# UNITED STATES PATENT AND TRADEMARK OFFICE

### Office Action Summary

10/671,842

### **DETAILED ACTION**

Stone of Murrin fig.1

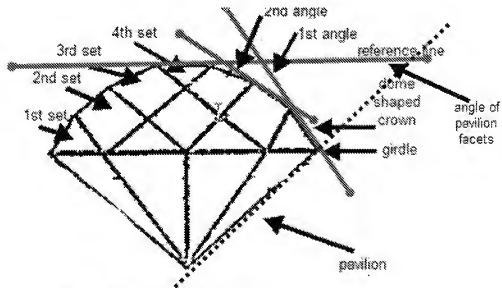
Regarding claim 47, Murrin discloses a diamond (line 56), comprising: a pavilion having a plurality of facets disposed from a girdle to a culet; and a dome-shaped crown disposed above the girdle, wherein the girdle extends no further than a widest circumference of the dome-shaped crown and the pavilion extends no further than a widest circumference of the girdle, the dome-shaped crown formed from a plurality of sets of facets cut with monotonically decreasing angles to form a curved contour in accordance with a dome shape from the girdle to an apex of the dome-shaped crown, as shown below.

**Stone of Murrin fig.1**

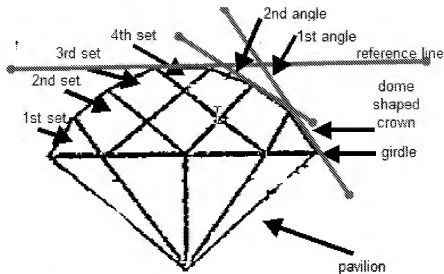
Regarding claims 52 and 53, Murrin discloses a diamond (line 56) of claim 47, but does not clearly disclose angles.

Fig. 5 of Meyer

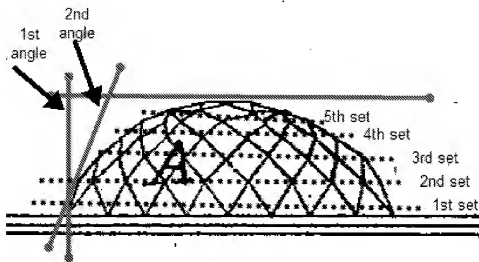
Meyer discloses a shape of a precious stone, figure 3, having a rounded dome in the form of a symmetrical hemisphere formed from at least five sets of facets between the girdle and the apex including a first set of facets disposed above the girdle and a second set of facets disposed between the first set of the facets and an apex of the crown, wherein the first set of facets is cut at a first angle with respect to a reference line which is tangential to the apex of the crown and the second set of facets is cut at a second angle with respect to the reference line which is less than the first angle, each facet within the first and second sets of facets having opposing corners of the hexagon nested between adjacent facets. The first set of facets is disposed in the crown adjacent to the girdle and cut about 90 degrees with respect to the reference line (as shown in the figure below) and the second set of facets is disposed in the crown adjacent to the first set of facets and cut about 75 degrees with respect to the reference

line, as well as the appropriate angle for the third, fourth and fifth set (from claims 52 and 53).

It would have been obvious to one of ordinary skill in the art at the time of the invention to desire of the dome shape of Meyer as the dome top of Murrin. Examiner contends that both disclose a stone with a domed top, desiring a rounded shape which is semi-spherical. It would have been obvious to apply the domed shape of Meyer to the domed top of Murrin, as it would result in the same aesthetic appearance. It would have been obvious to one of ordinary skill in the art at the time the invention was made to increase the number and sets of facets, since it has been held that mere duplication of the essential working parts of a device involves only routine skilled the art. *St. Regis*
